# Access Compliance Report

## Public Rights-of-Way

Intersection ID: 28372	Main Street: CONSTITUTION_HALL_DR	Cross Street: HIGHLANDS_CROSSING_DR	Location: SE
ADA ID: 5C6F48ED6C86	Ramp Type: PerpDiag	Initial Pass/Fail: Fail	Overall Compliance: No
		Severity Score: 12.5

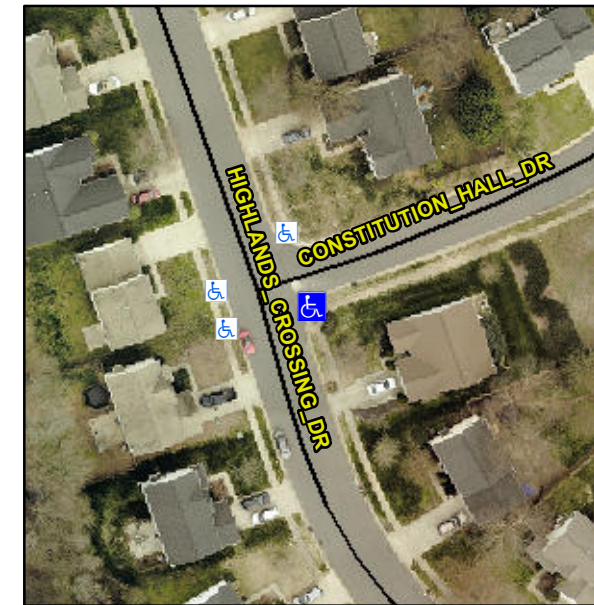
**Not Found, R304.5.3**

Compliance	Description	Data	Compliance	Description	Data
N/A	Ramp Length (in)	42.0	Yes	Ramp Slope (%)	6.5
Yes	Ramp Width (in)	48.0	No	Ramp XSlope (%)	6.7
N/A	Flare Type LT	N/A	N/A	Flare Type RT	N/A
N/A	Flare Slope LT (%)	N/A	N/A	Flare Slope RT (%)	N/A
N/A	Flare Traversable LT?	N/A	N/A	Flare Traversable RT?	N/A
N/A	Landing Length (in)	N/A	N/A	DWS Provided?	N/A
N/A	Landing Width (in)	N/A	N/A	DWS Contrast?	N/A
N/A	Landing Slope (%)	N/A	N/A	DWS Length (in)	N/A
N/A	Landing X Slope (%)	N/A	N/A	DWS Full Width?	N/A
N/A	Landing Curb? (Y/N)	N/A	N/A	DWS Offset (in)	N/A
N/A	Shared Landing?	N/A			
N/A	Gutter Ponding?	N/A	N/A	Gutter Slope (%)	N/A
N/A	Gutter Lip Ht (in)	N/A	N/A	Gutter X Slope (%)	N/A
N/A	Painted X Walk1?	No	N/A	Painted X Walk2?	No
	X Walk 1 Direction	To N		X Walk 2 Direction	To W
N/A	X Walk 1 Width (in)	N/A	N/A	X Walk 2 Width (in)	N/A
	X Walk 1 Slope (%)	3.0		X Walk 2 Slope (%)	1.0
	X Walk 1 X Slope (%)	4.1		X Walk 2 X Slope (%)	2.3

**Remove & Replace Curb Ramp With Two New Directional Ramps or Equivalent.**
